WYOMING DEPARTMENT OF ENVIRONMENTAL QUALITY COMMENTS

Section 1.3 of the Draft Environmental Assessment (The Proposed Actions)

Figure 1. Water Level Recovery at MW-109

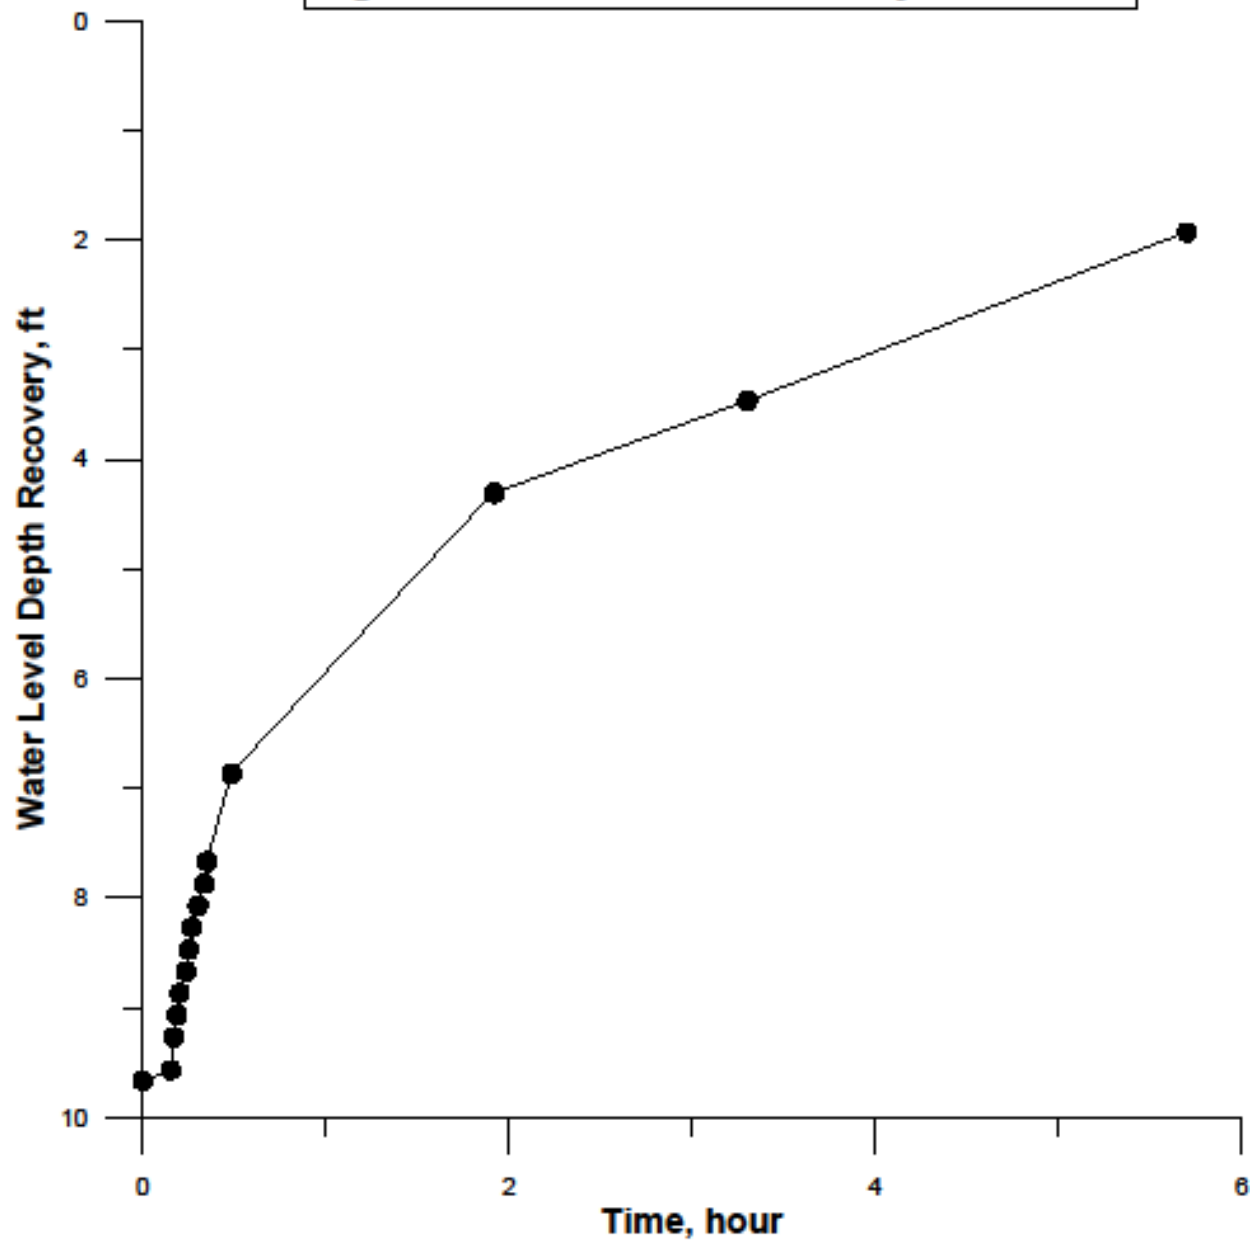
Comment 2. The results from the current fate and transport modeling are not valid. Fate and transport modeling should be applied to demonstrate that the predicted concentrations of these contaminants at the proposed POE wells does not exceed their respective Federal SDWA [Safe Drinking Water Act] MCLs (or State standards), or baseline concentrations (at the POE wells), whichever is greatest. Contaminant limits at the POE wells should adhere to Federal SDWA MCLs (or State standards), or baseline concentrations (at the POE wells), whichever is greatest. **(WQD)**

The constructed fate and transport model has captured essential features of the site, including subsurface geology and geochemical processes. As with any model, it has its limitations. The modeling results have been hindered by the extreme complexities associated with spatial variability. The model results at the proposed POE well MW-109 indicate that uranium concentrations are overestimated with a peak of 460 pCi/L. NRC asked the licensee to review the modeled value for POE well MW-109 and submit revised model results that more accurately reflect the measured values. In September 2012, the licensee, through its contractor Tetra Tech Geo (see ML12270A289), submitted revised predictions of uranium concentrations along Lang Draw which show a much better fit for POE well MW-109 when compared to measured values.

The measured values of uranium in well MW-109 from 2002 to 2012 are listed below.

The background water quality for uranium was established in well No. MW-9 to be 98.7 pCi/l (NRC, 1996, TER to establish background—ML12270A290). In order to demonstrate that the selection of well MW-9 as a background well is valid, the licensee determined the variation trends for “mobile species” through the time period from 1988 to 1995. The “mobile species” are pH, conductivity, total dissolved solids, chloride, and sulfate. In March 1993, total dissolved solids, chloride, and sulfate increased while prior to this date the “mobile species” were stable. Consequently, the licensee excluded data collected after March 1992 and established background for hazardous constituent concentrations as the mean plus two standard deviations. The NRC reviewer also noted that the ground water in the N-sands is naturally brackish and would be restricted to raising livestock.

The estimated level of risk using the overestimated concentrations at the POE well MW-109 is on the order of 10^{-4} , similar to the background risk for the site, and is acceptable under NUREG-1620, Rev.1 (NRC, 2003). Under 10 CFR Part 40, Appendix A, Criterion 5(B)(6), the NRC will establish site specific alternative concentration limits if it finds that the limits proposed by the licensee are as low as reasonably achievable and that there is not a substantial present or potential hazard to human health or the environment as long as the alternative concentration limits are not exceeded. The NRC is not required to compare contaminant values at a POE well to Federal or State ground water quality standards when making determinations under Criterion 5(B)(6). NRC staff has determined that the proposed ACLs for the site meet Criterion 5B(6) of 10 CFR Part 40 Appendix A.
